<b>Well Name:</b> DAZED BDZ FEDERAL COM	<b>Well Location:</b> T21S / R24E / SEC 3 / LOT 5 / SWNW /	<b>County or Parish/State:</b> EDDY / NM
<b>Well Number:</b> 1	<b>Type of Well:</b> CONVENTIONAL GAS WELL	<b>Allottee or Tribe Name:</b>
<b>Lease Number:</b> NMNM0230377B	<b>Unit or CA Name:</b> 1 DAZED BDZ FEDERAL COM	<b>Unit or CA Number:</b> NMNM111038
<b>US Well Number:</b> 300153309000D2	<b>Well Status:</b> Inactive	<b>Operator:</b> EOG RESOURCES INCORPORATED

**Notice of Intent**

**Type of Action:** Plug and Abandonment

Dazed BDZ Federal Com 1 Proposed

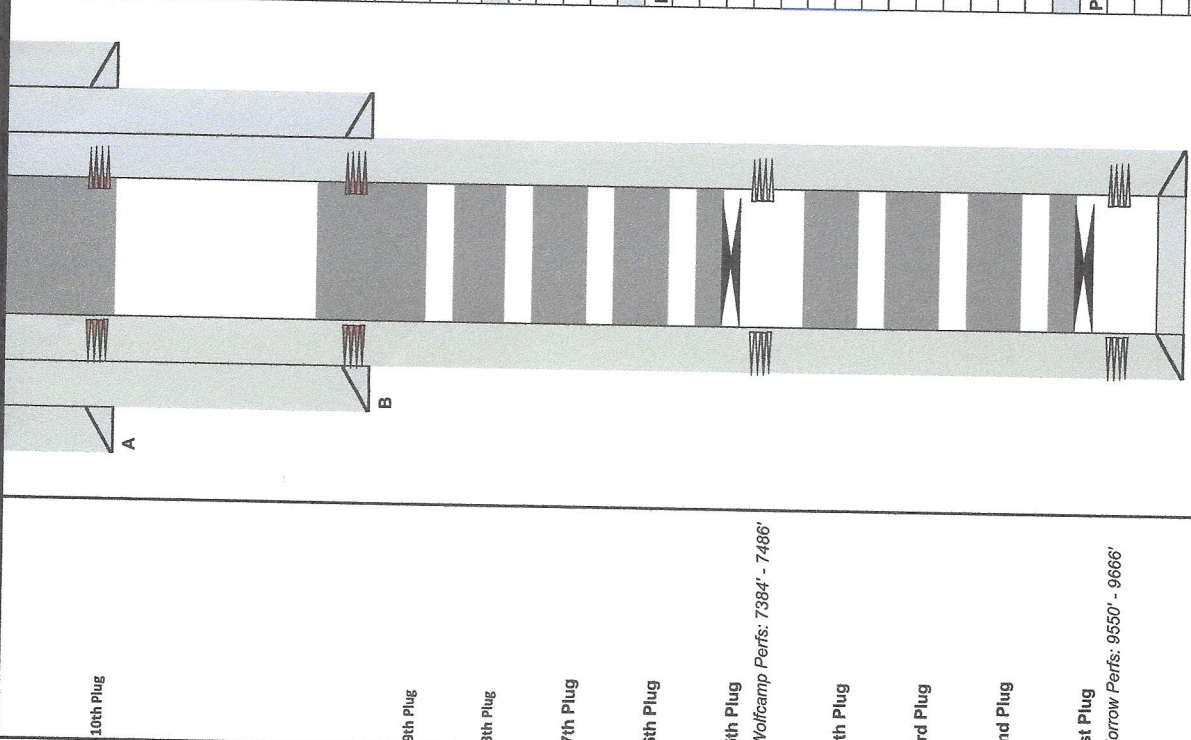
1. MIRU all safety equipment as needed. NU BOP. POOH with production equipment.
2. Set a CIBP at 9500 ft with ~~7~~ <sup>25</sup> sx Class H cement on top to ~~9465~~ <sup>9386</sup> ft. WOC and tag. This will cover Morrow perms.

7. Spot a ~~31~~ <sup>35</sup> sx Class C cement plug from 6878 ft – ~~6710~~ ft. This will cover Wolfcamp top. *6878' - 6676'*
8. Spot a 30 sx Class C cement plug from 6575 ft - 6410 ft. This will cover 3<sup>rd</sup> Bone Spring top.

11. Perforate at 445 ft. Spot a 73 sx Class C cement plug from 445 ft up to surface. WOC and tag. Backfill as needed. *Verify@surface*
12. Cut off wellhead and install dry hole marker. Clean location as per regulated.
